The Corporation of the
Town of Milton
Committee of Adjustment and Consent

Thursday, June 26, 2025, 6:00 p.m.
Council Chambers - In Person

The Corporation of the
Town of Milton
Committee of Adjustment Minutes

Figure 1 - Site Plan

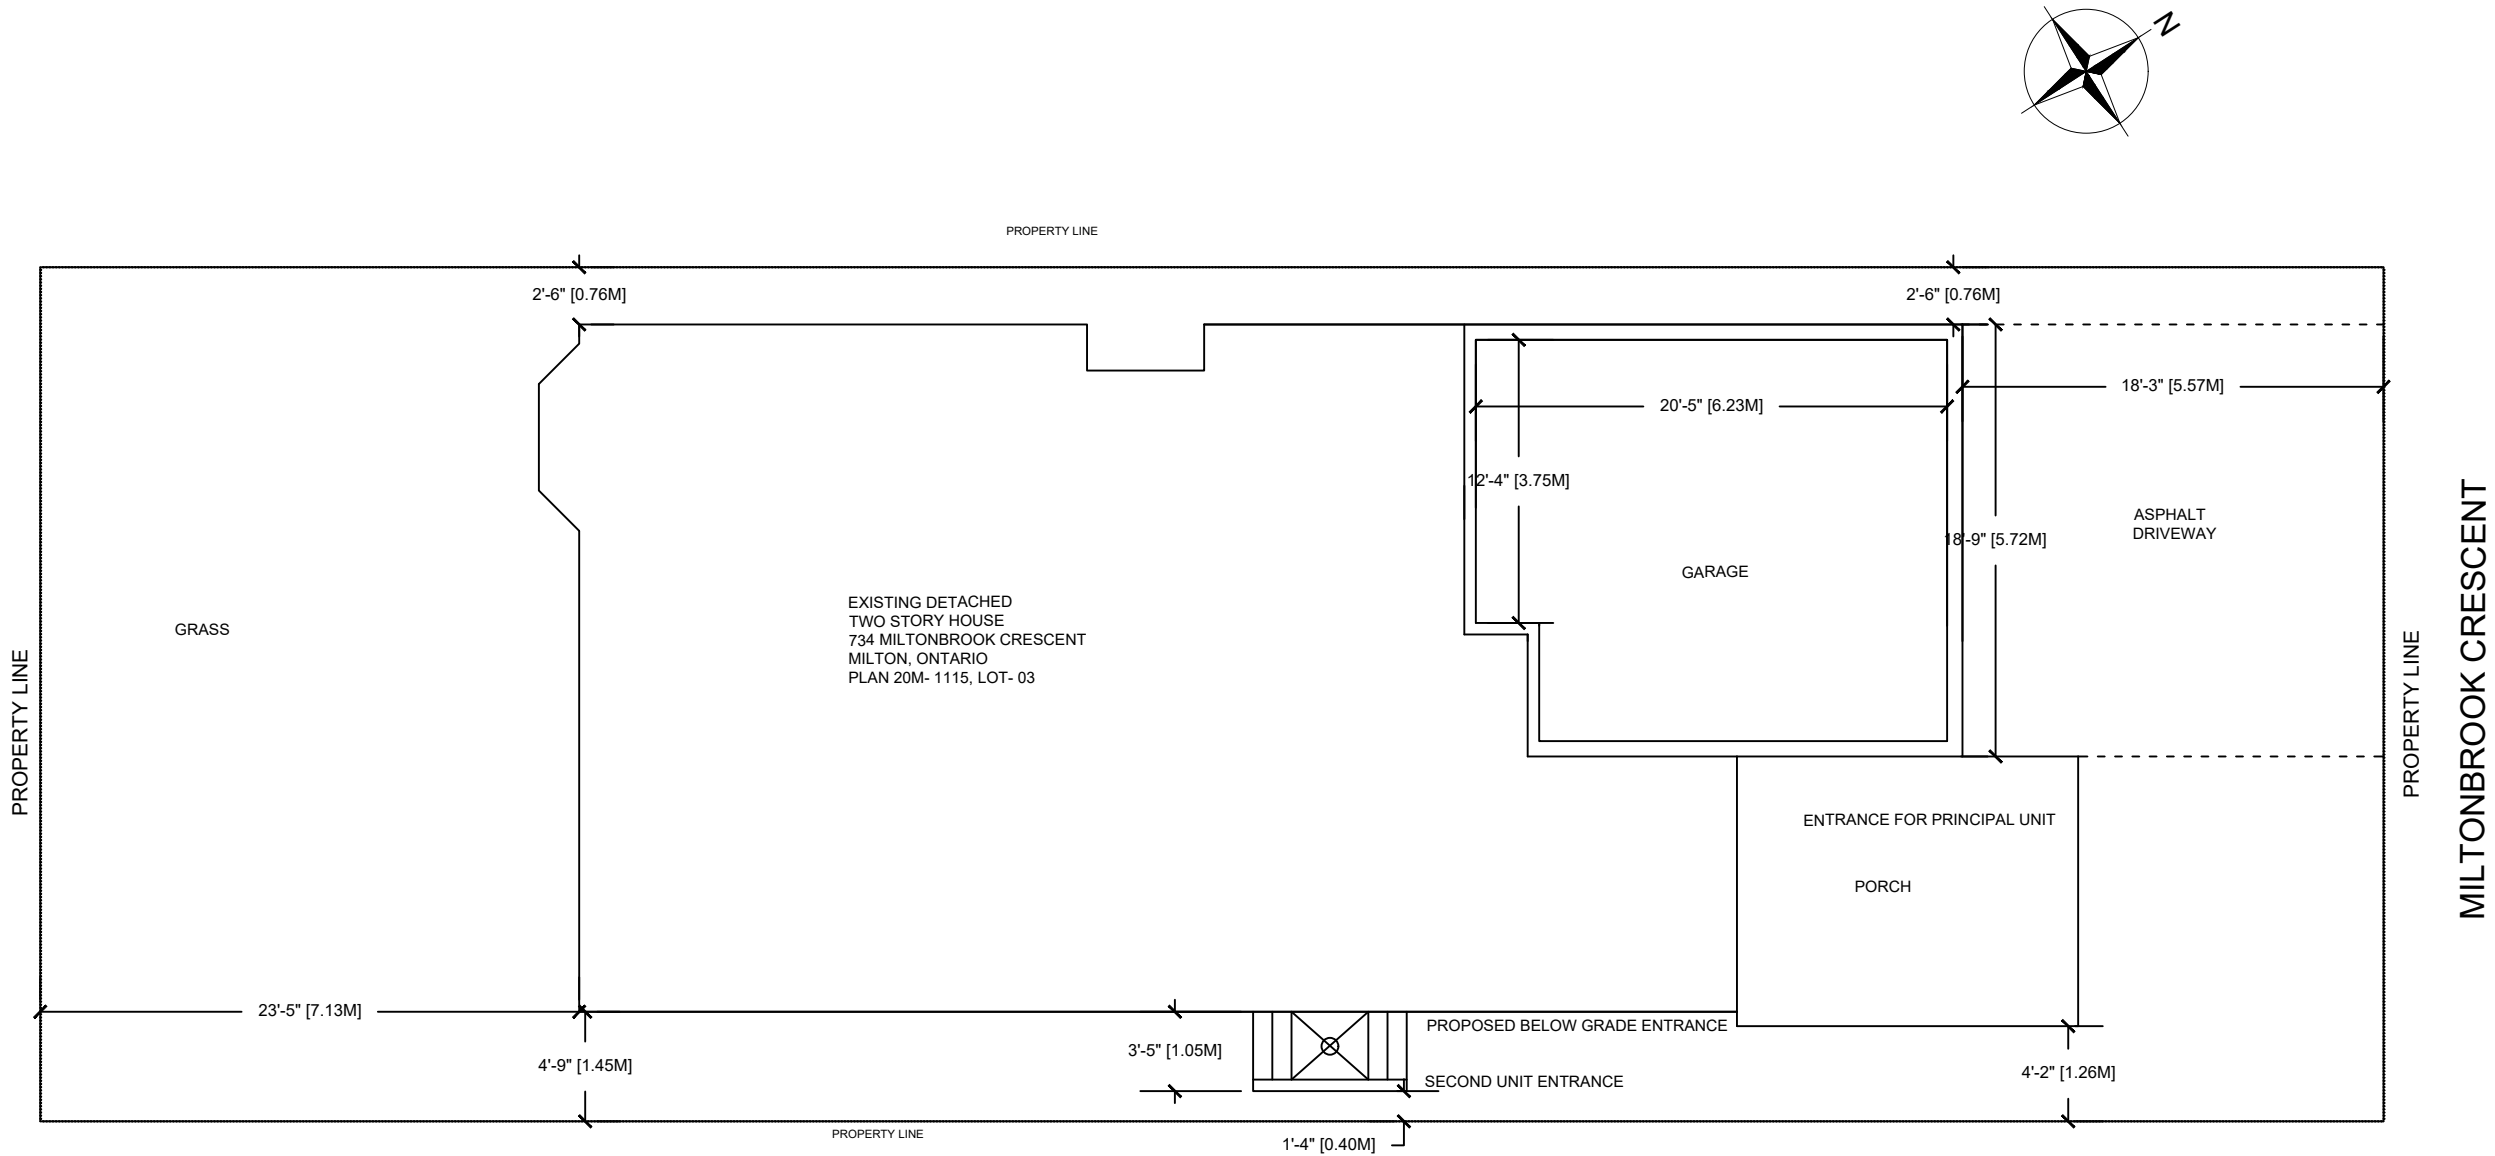
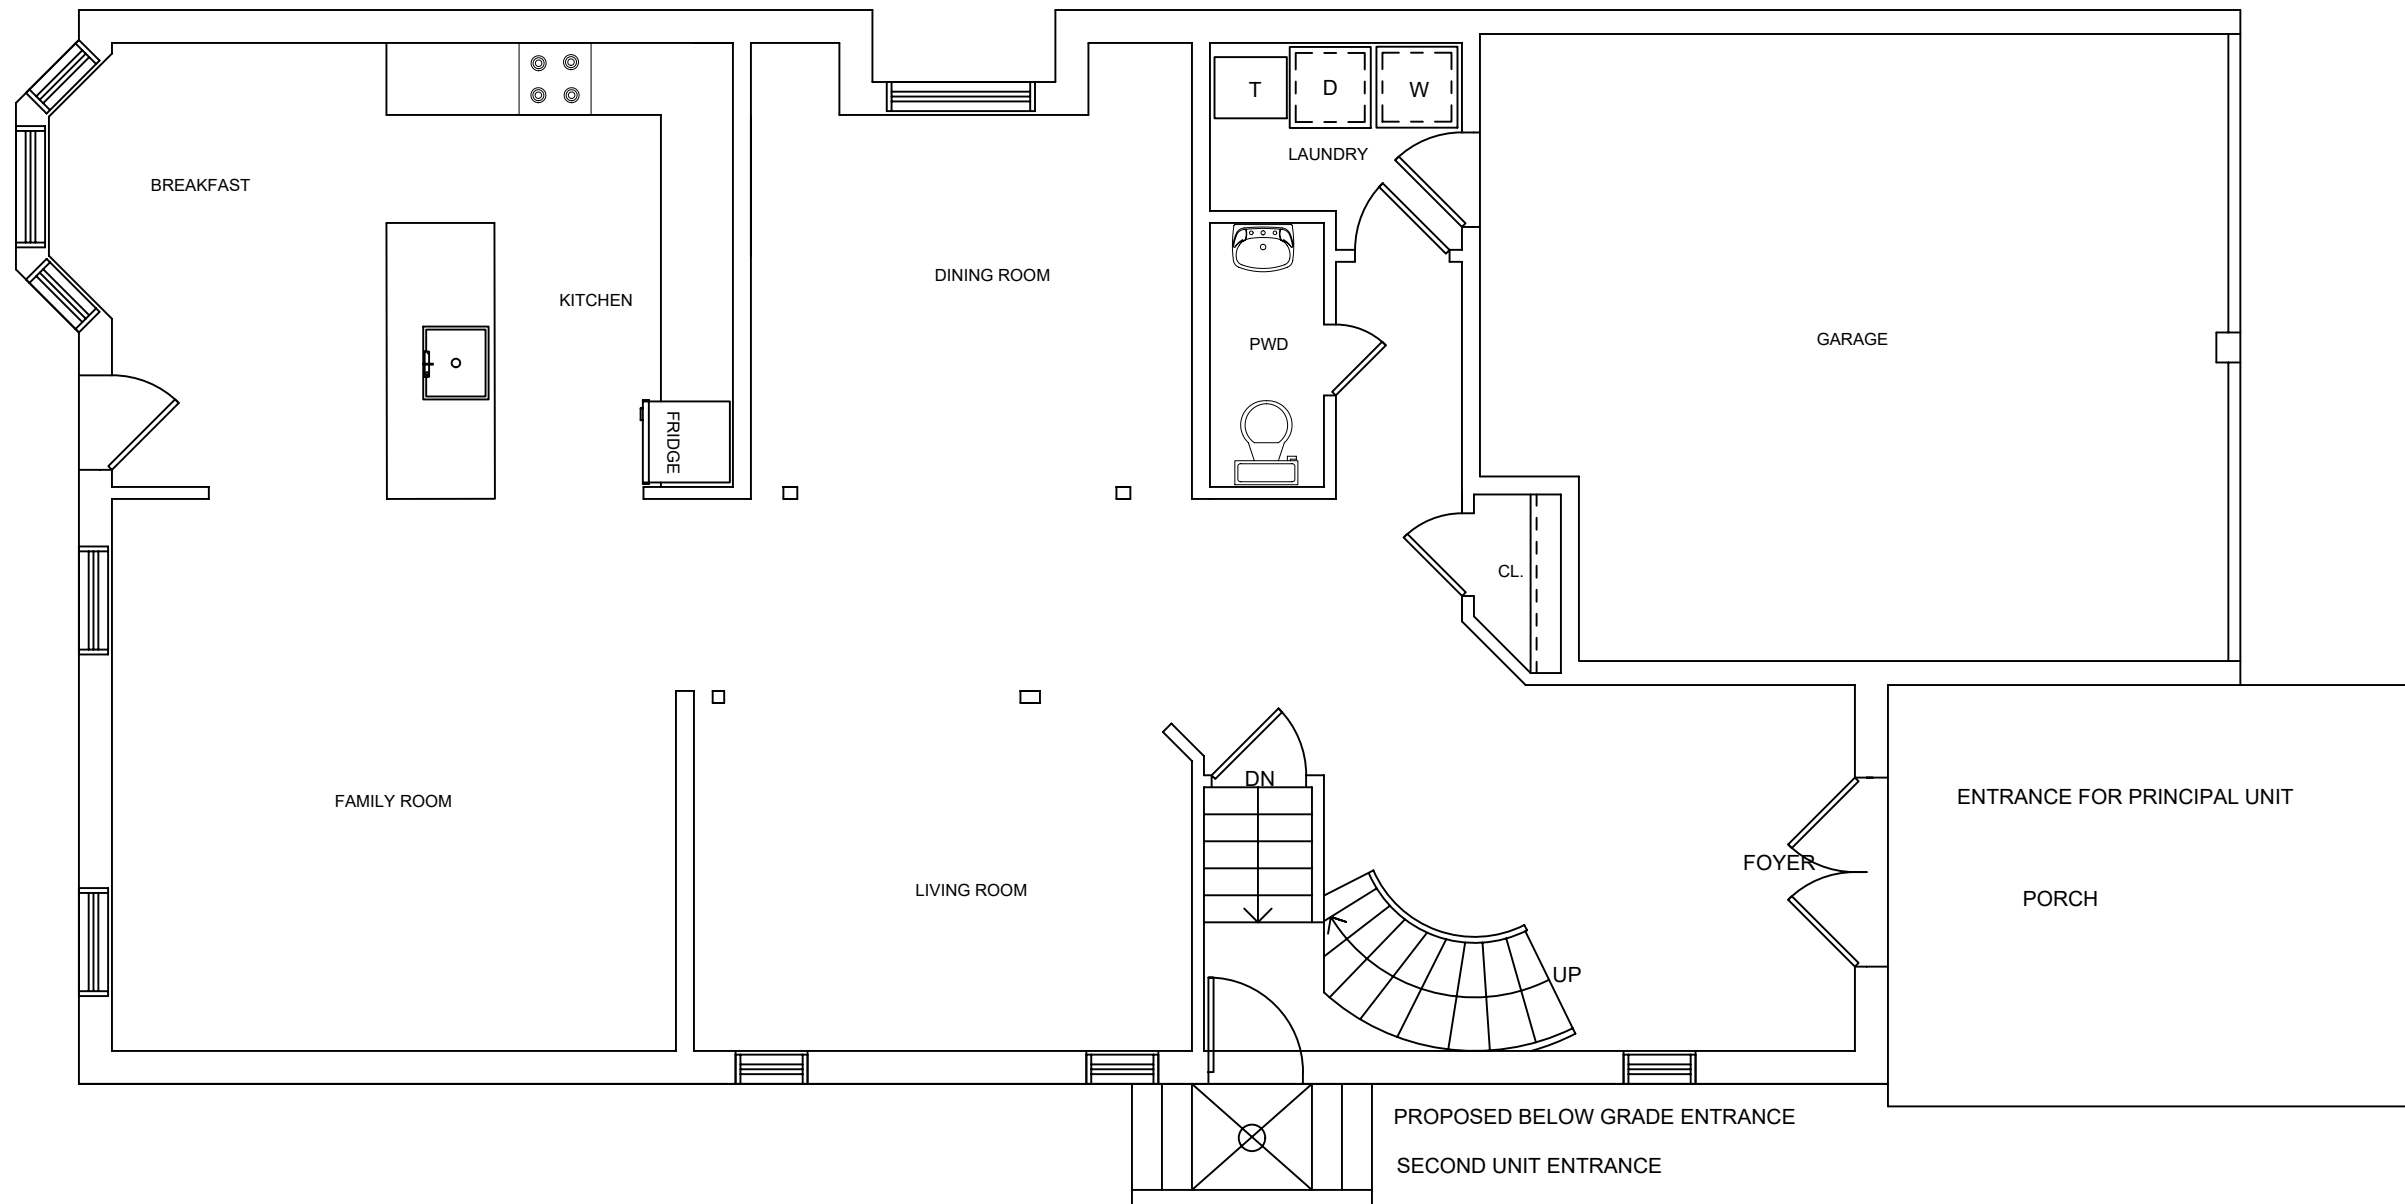
Section 4.19.5 Table 4H of the Town's Zoning By-law only permits below-grade stairs to encroach into a required rear or exterior side yard. The applicant is requesting permission to allow for below-grade stairs to be located in the interior side yard and to encroach 0.80 metres, to facilitate the proposed development.

Milton Fire is supportive of the application subject to a residential sprinkler system being installed within the ARU. The intent of this is to mitigate any impact associated with the proposed obstruction being located within the pedestrian access. By providing fire suppression measures such as a sprinkler system, this will allow firefighters additional response time when accessing the unit if the obstruction slightly delays access.

Planning staff note that the proposed encroachment for the below-grade entrance and stairs will only impact a small portion of the interior side yard and the remaining area will be unobstructed. Further, the proposed encroachment does not exceed the current 0.30 metre allowance associated with permitted encroachments set out in Section 4.10 vii) of the Town's Zoning By-law and is consistent with established performance standards and meets requirements and the review of Town Engineering Staff.

Therefore, it is Planning Staff's opinion that the encroachment does not render the unobstructed pedestrian access inadequate, and it can function as intended, subject to a residential sprinkler system being installed within the ARU. While the pedestrian access provides a path of travel to and from the unit, the fire suppression measure will aid in mitigating any delay in accessing the unit that may be caused by the proposed obstruction and therefore, does not jeopardize the overall safety of the unit nor its tenants.

1. That the development shall be constructed in accordance with the site plan prepared by Heritage Solutions and stamped by Town Zoning on May 27, 2025.
2. That prior to Building Permit issuance, the applicant incorporates a sprinkler system, designed by a qualified professional in fire protection systems and in accordance with NFPA 13D standards, within the building permit package for the proposed Additional Residential Unit;
3. That a Building Permit be obtained within two (2) years from the date of the decision; and
4. That the approval be subject to an expiry of two (2) years from the date of decision if the conditions are not met, if the proposed development does not proceed and/or a building permit is not secured.

Figure 1 - Site Plan

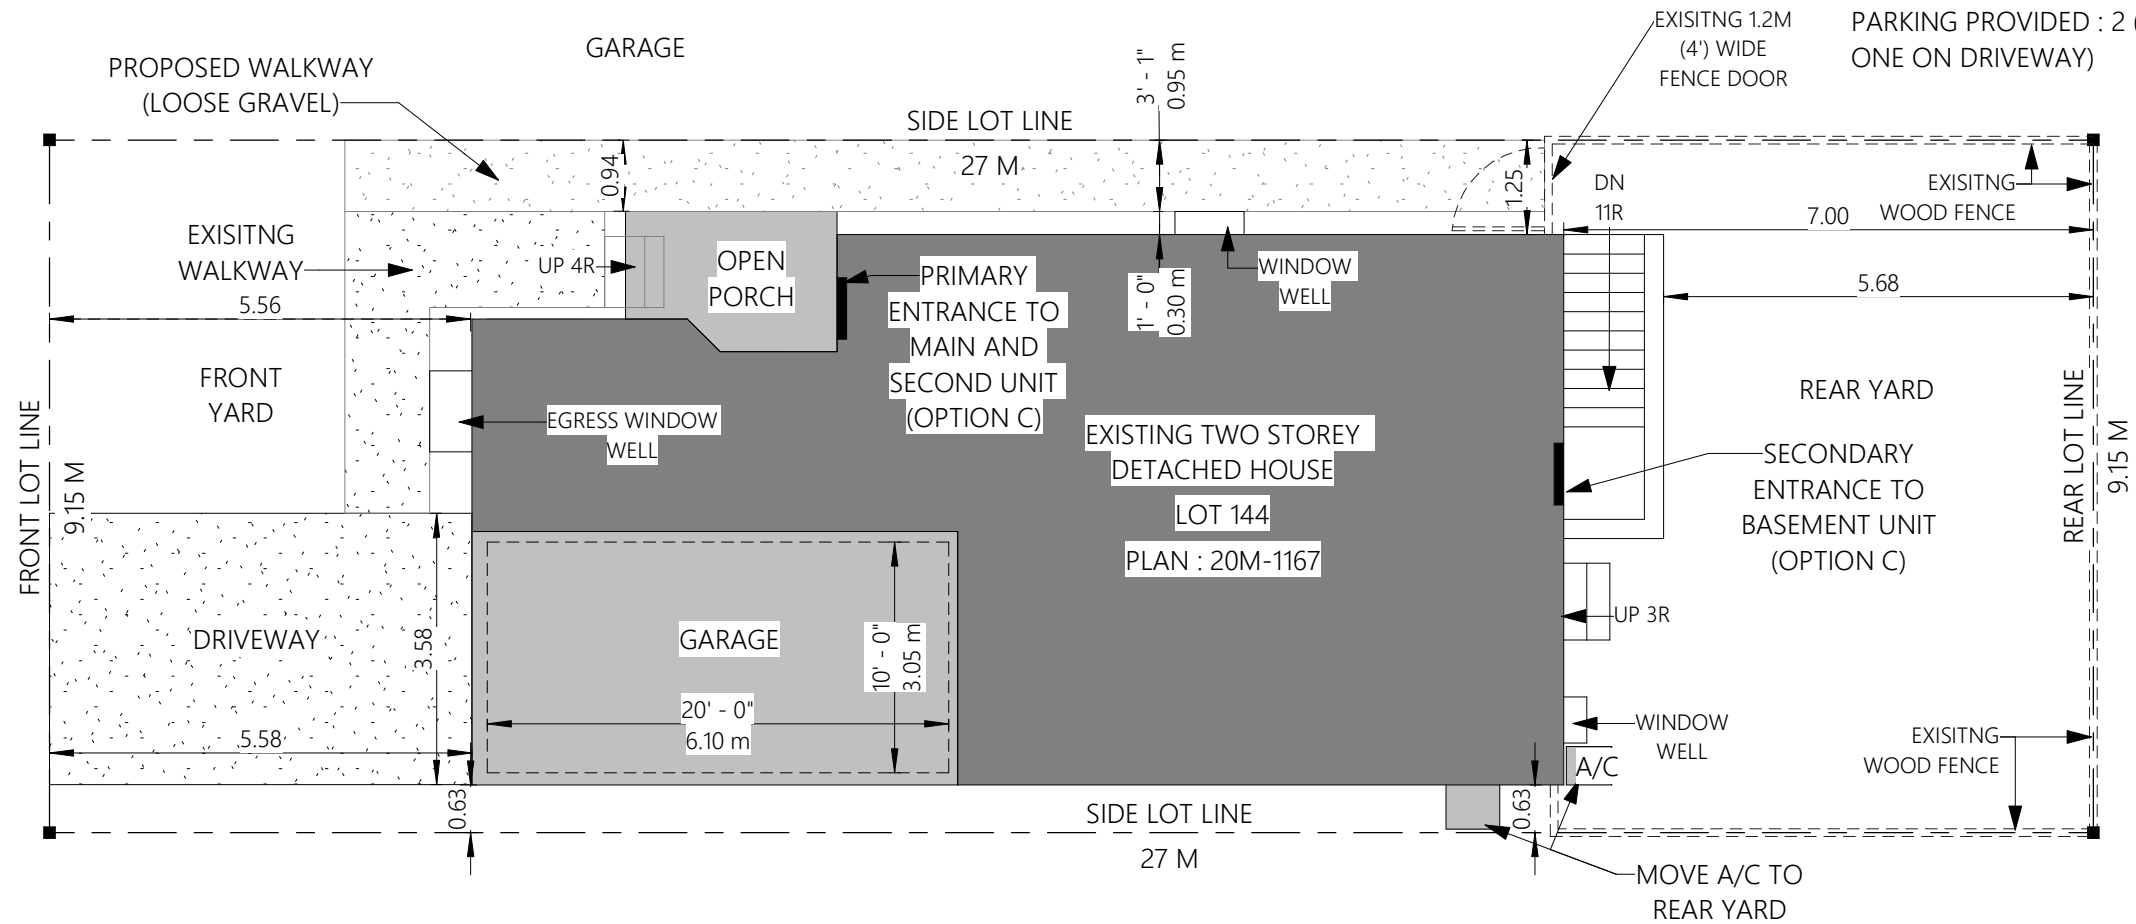
The applicant has requested permission to allow for a porch to encroach 0.26 metres into the unobstructed pedestrian access, to facilitate the proposed development. With the exception of the above-noted relief, the proposal maintains all other provisions of the Urban Zoning By-law 016-2014, as amended.

The applicant is requesting permission to allow for an existing porch encroachment of 0.26 metres into the required 1.2 metres unobstructed interior side yard. Section 4.10 vi) of the Town's Zoning By-law requires that a 1.2 metre wide unobstructed pedestrian access between the street line and primary entrance to the ARU be provided. Further, Section 4.10 (vii) allows certain encroachments, however, a porch or other architectural features are not explicitly included.

The porch is located at the front of the dwelling and does not encroach into the entire interior side yard. It should be noted that the majority of the interior side yard will meet the 1.2 metre minimum requirement. Further, the applicant has opted for a rear yard entrance to limit further activity and development within the interior side yard which is favourable. Planning staff acknowledge that the porch is existing and the front façade and interior side yard will not require any changes to facilitate the proposed development.

1. That the development shall be constructed in accordance with the site plan prepared by ArchiStudios Inc. and dated and stamped by Town Zoning on May 26, 2025.
2. That prior to Building Permit issuance, the applicant incorporates a sprinkler system, designed by a qualified professional in fire protection systems and in accordance with NFPA 13D standards, within the building permit package for the proposed Additional Residential Unit;
3. That a Building Permit be obtained within two (2) years from the date of the decision; and
4. That the approval be subject to an expiry of two (2) years from the date of decision if the conditions are not met, if the proposed development does not proceed and/or a building permit is not secured.
